ORIGINATION FORM

Proposed Revisions to a Standard Plans Index
(Please provide all information — Incomplete forms will be returned)

Index Number: 695-001
Sheet Number (s): 1 through 7
Index Title: Traffic Monitoring Sites

Index Number: 695-001
Sheet Number (s): 6-7
Index Title: Traffic Monitoring Site

LANE CONFIGURATION FOR TMS INDUCTIVE LOOP AND QUARTZ PEXO AXLE SENSOR

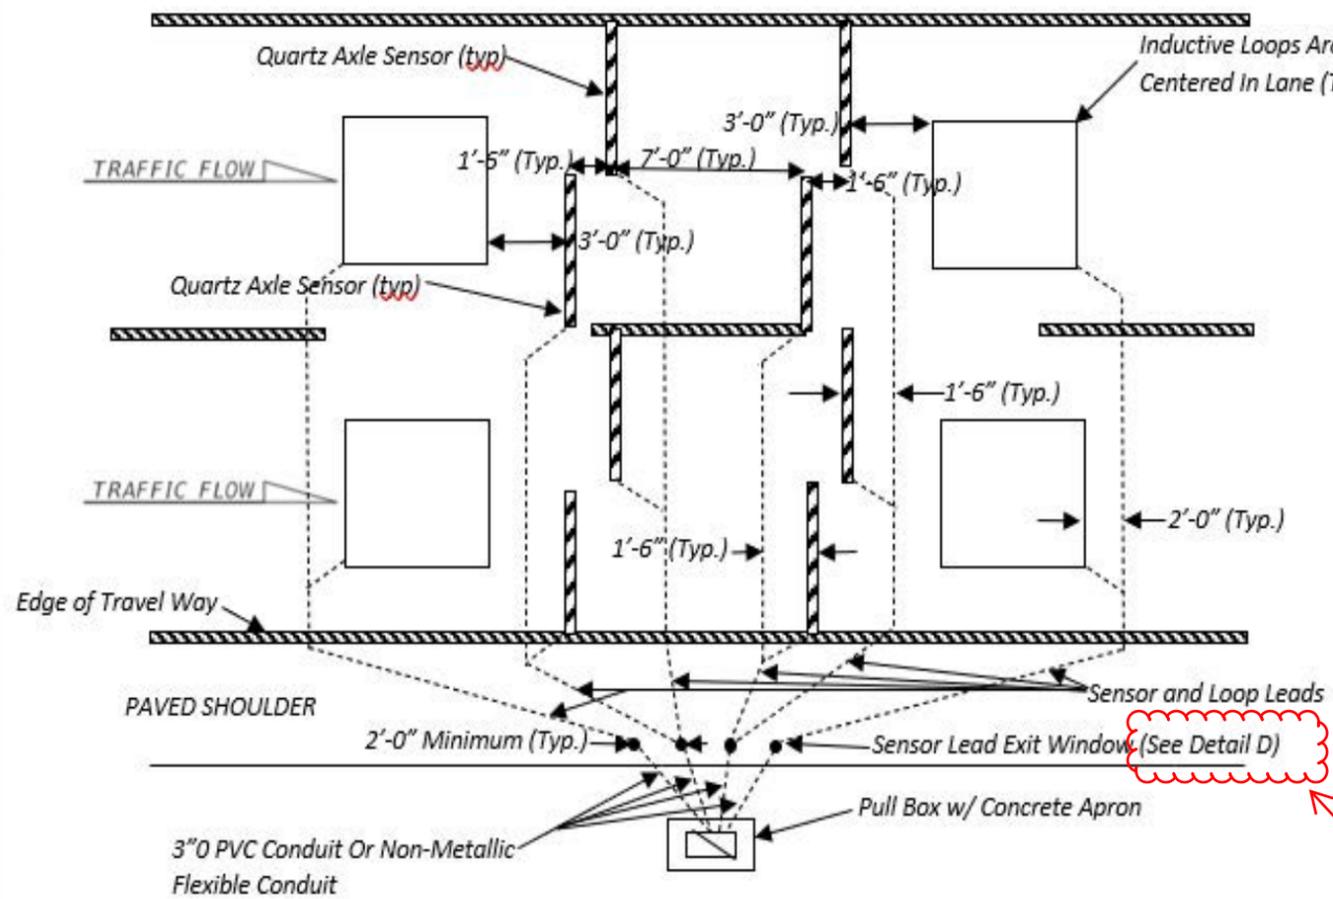
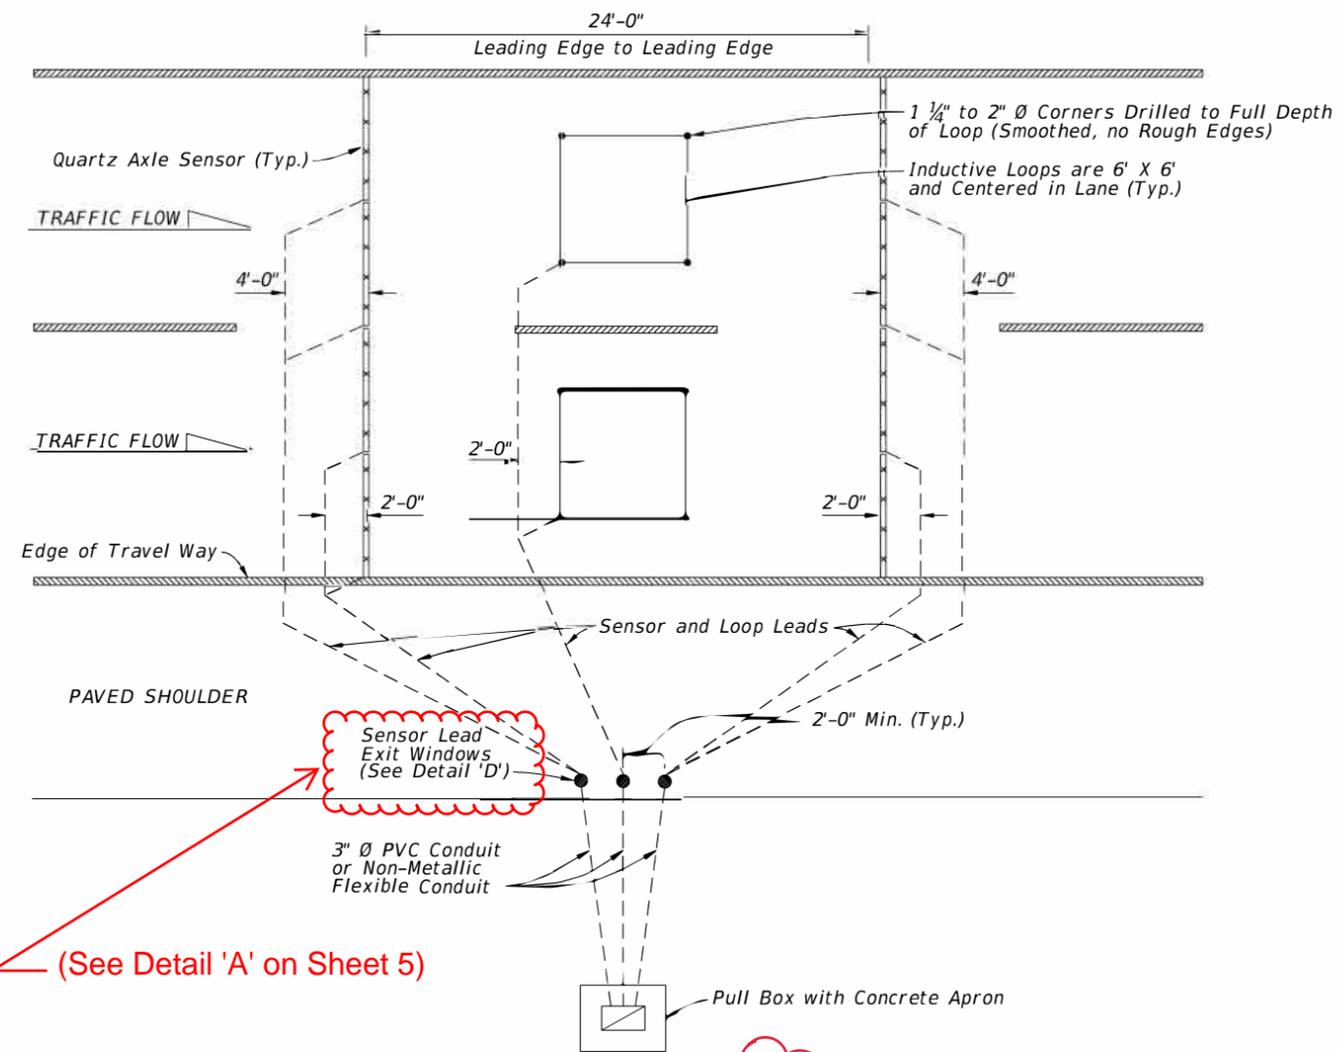
Note: Configuration A and Configuration B are based on the vehicle speed/classification unit. Contact the TMS Manager in the Transportation Data and Analytics Office for correct layout.

NEW SHEET 7

LAST REVISION 11/01/17	DESCRIPTION: 11/01/21	 FY 2021-22 STANDARD PLANS	TRAFFIC MONITORING SITE	INDEX 695-001	SHEET 6 of 8 of 9
--------------------------------------	--------------------------	---	-------------------------	------------------	---------------------------------

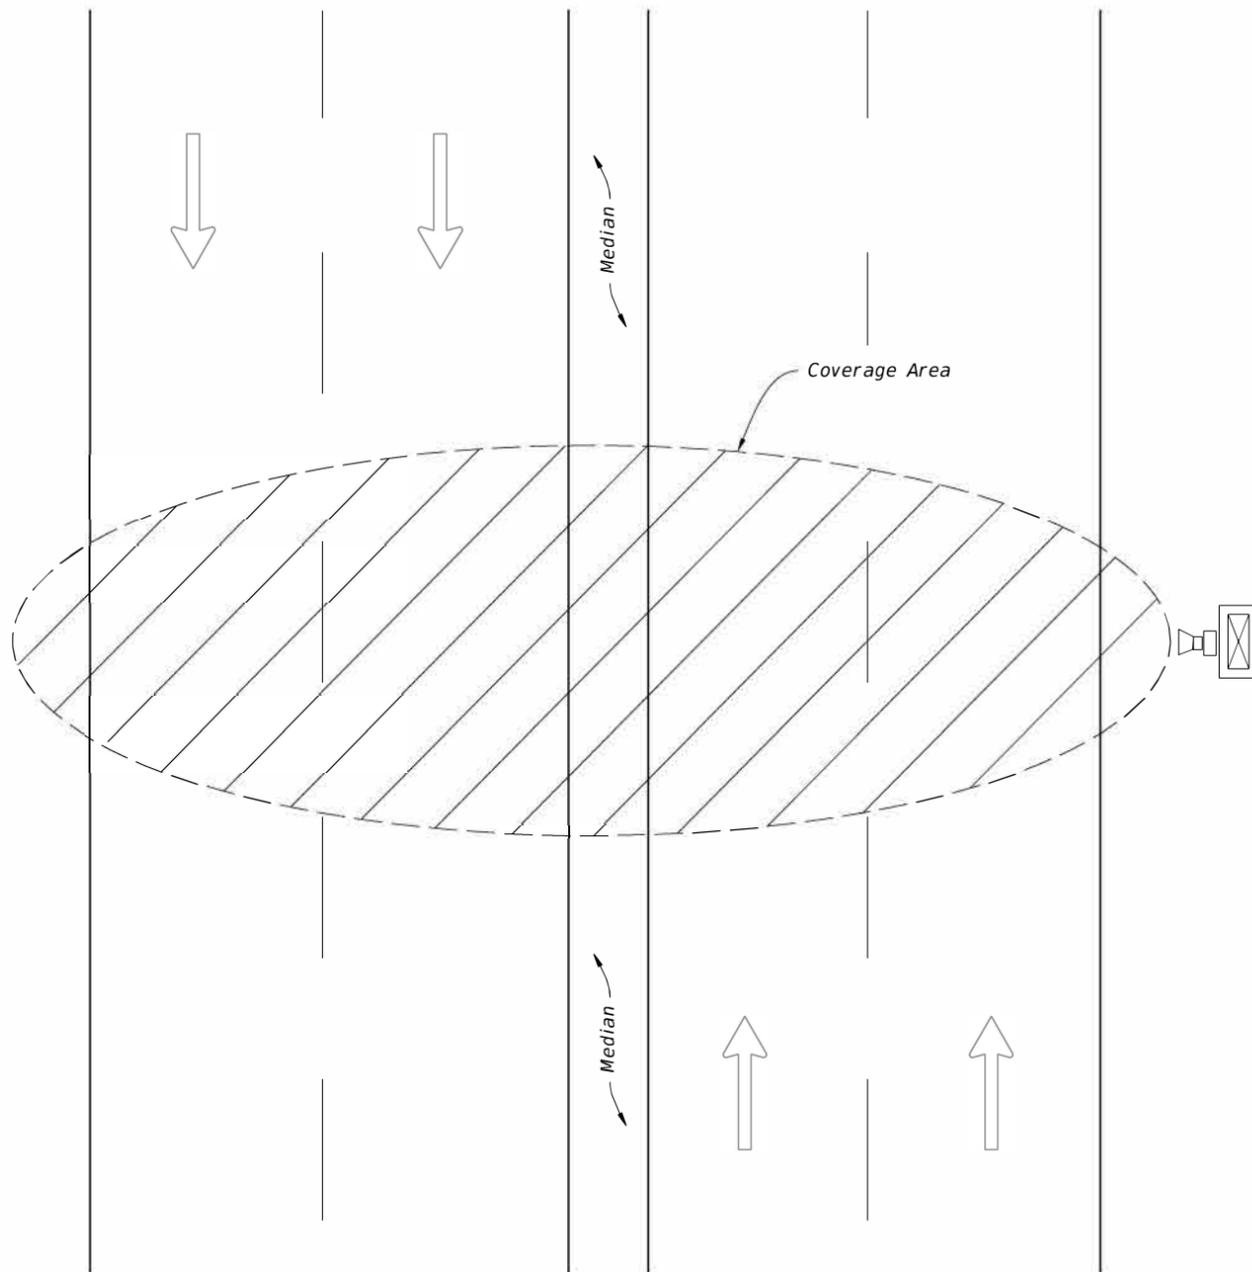
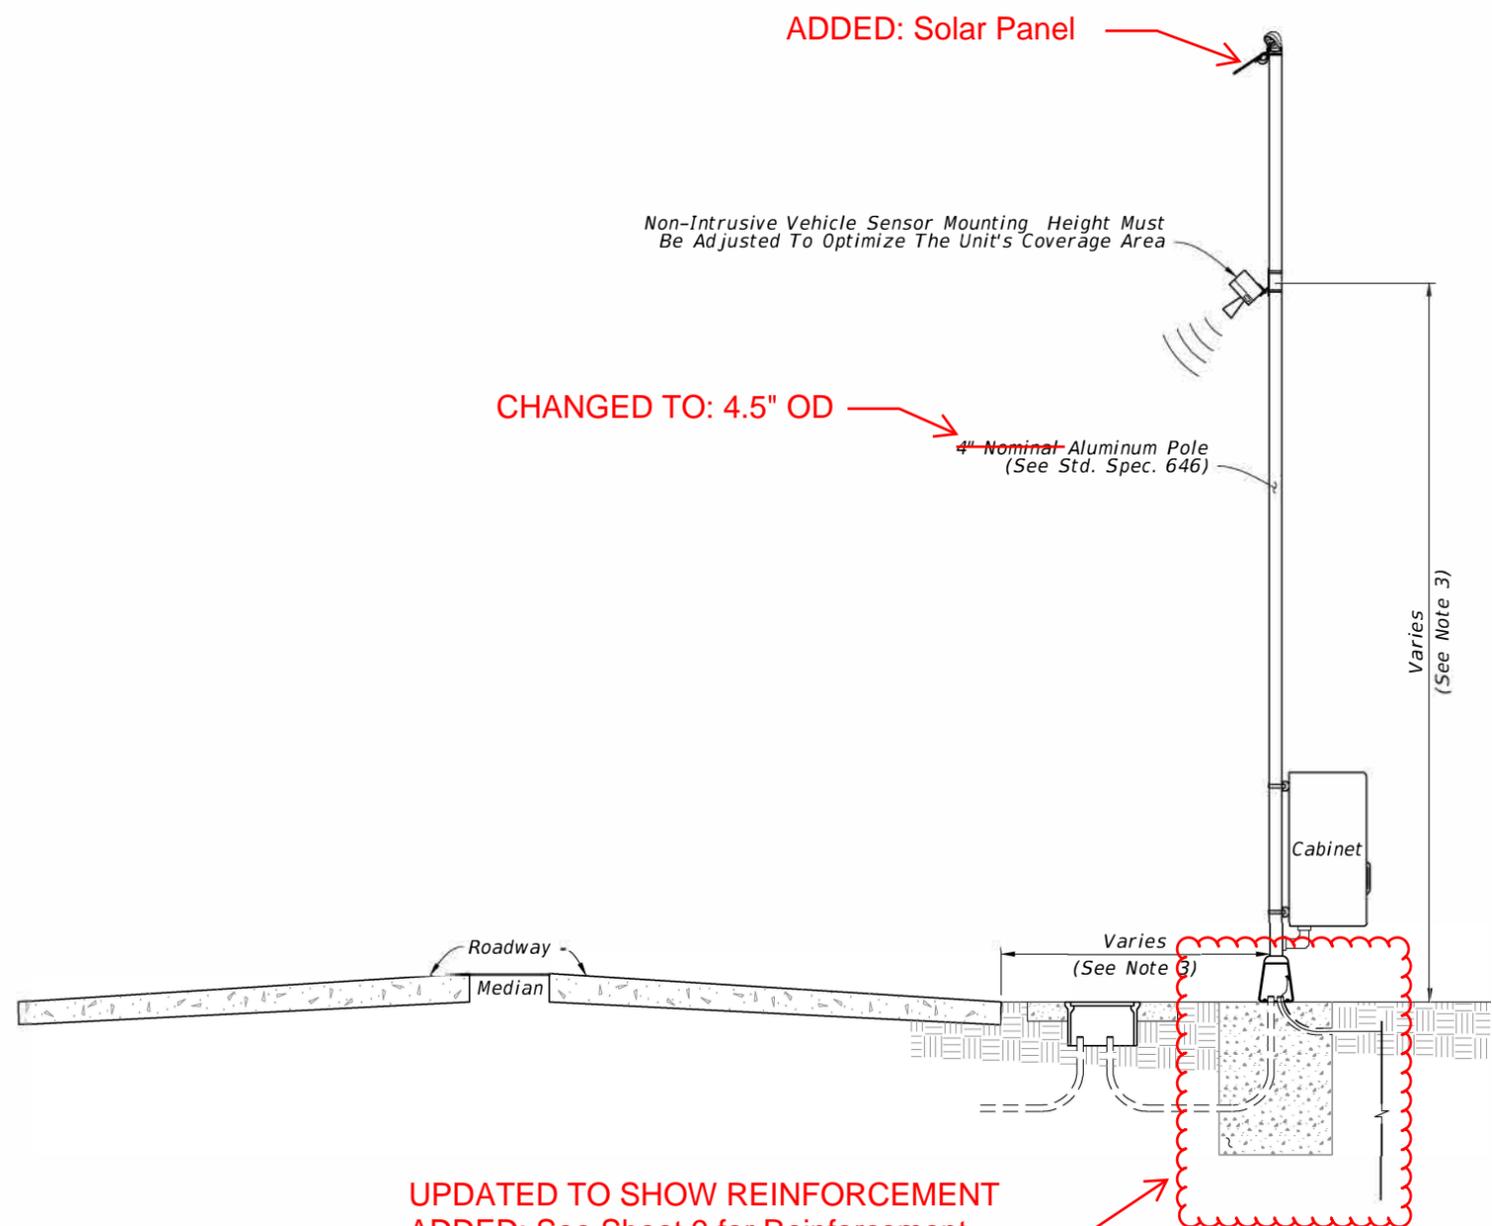
- Sheet 6 (New Sheet 8) - Update Elevation View to match foundation details on Sheet 7 (New Sheet 9); Change "4" Nominal Aluminum Pole" to "4.5" OD Aluminum Pole; Added Solar Panel callout.
- Sheet 7 (New sheet 9) - Update Foundation Details to show bars and stirrups; Update note 2 to reference Spec 646; Update Note 6; Change all references "4" Nominal Aluminum Pole" to "4.5" OD Aluminum Pole.

NOTE:

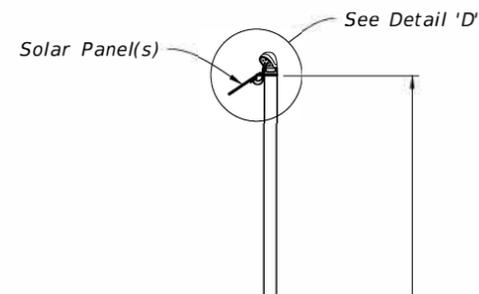
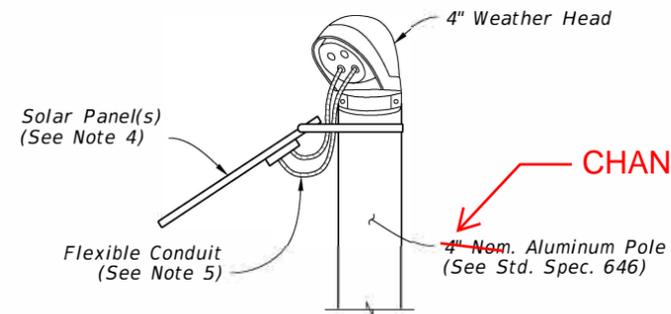
UPDATED NOTE 2: Meet the material requirements of Specification 646.

1. Cabinet installed per Index 676-010 except cabinet center will be 4 feet above grade.
2. ~~Place pole in accordance with the Standard Specification 125.4 and 125.8.2.~~

- b. 12', 15' or 20' poles: ~~3'-0" X 3'-0" wide, a depth of 3'-0"~~
 - c. 30' or 35' poles: ~~3'-0" X 3'-0" wide, a depth of 4'-0"~~
20' or 30'

UPDATED NOTE 6b and 6c.

DETAIL 'D'

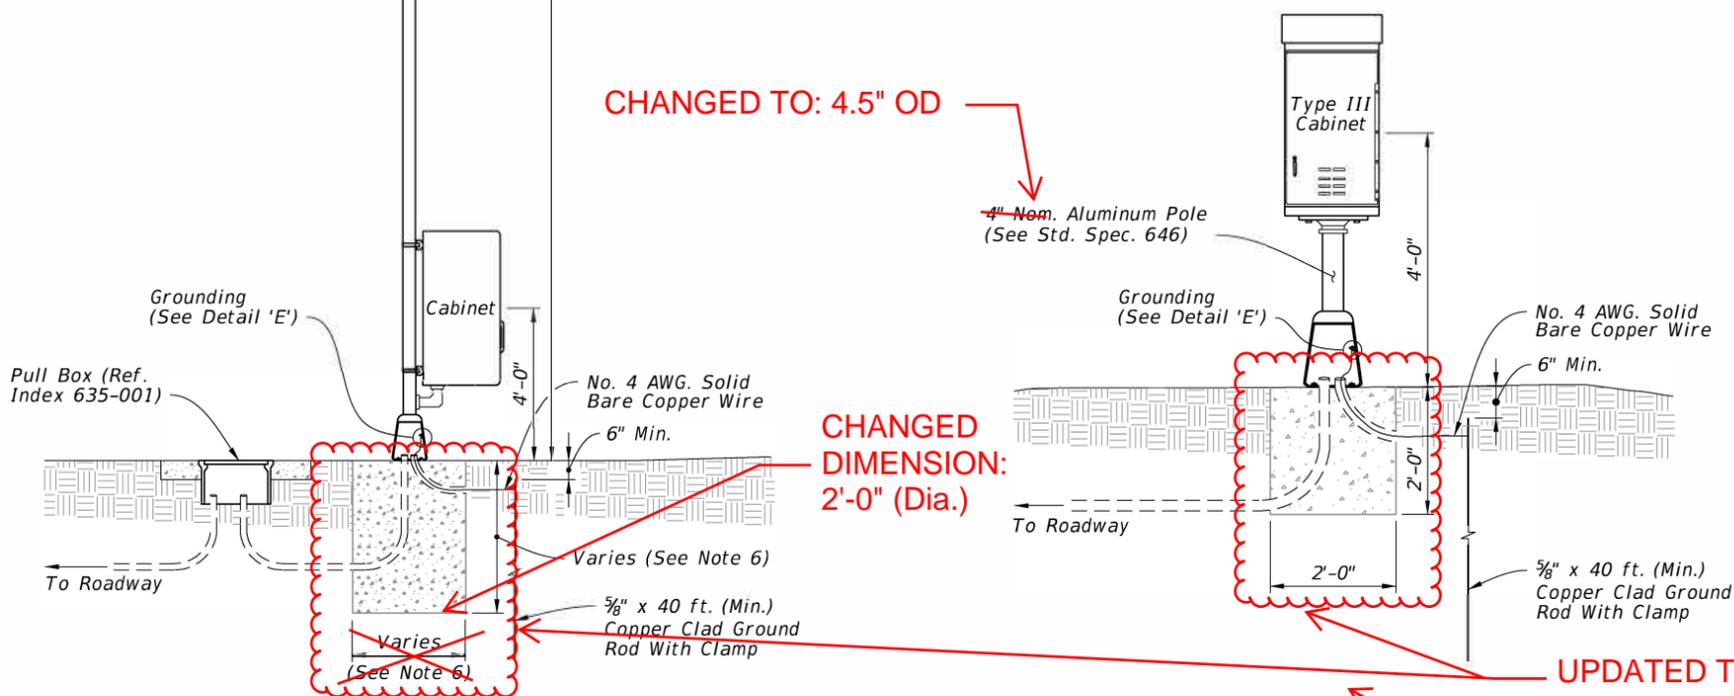
CHANGED TO: 4.5" OD

~~4" Nom. Aluminum Pole (See Std. Spec. 646)~~

CHANGED TO: 4.5" OD

CHANGED TO: 4.5" OD

CHANGED DIMENSION: 2'-0" (Dia.)

UPDATED TO SHOW REINFORCEMENT

DETAIL 'E'

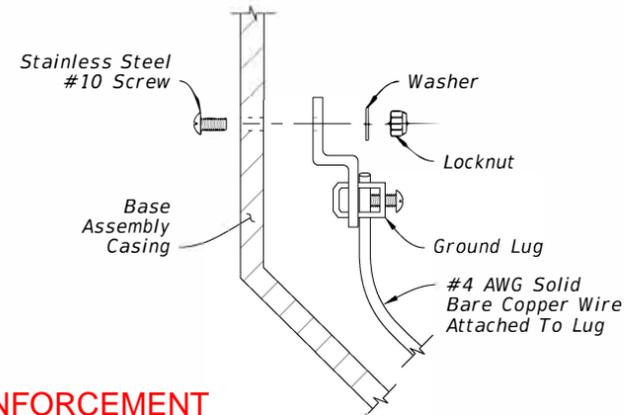
ADDED: ELEVATION
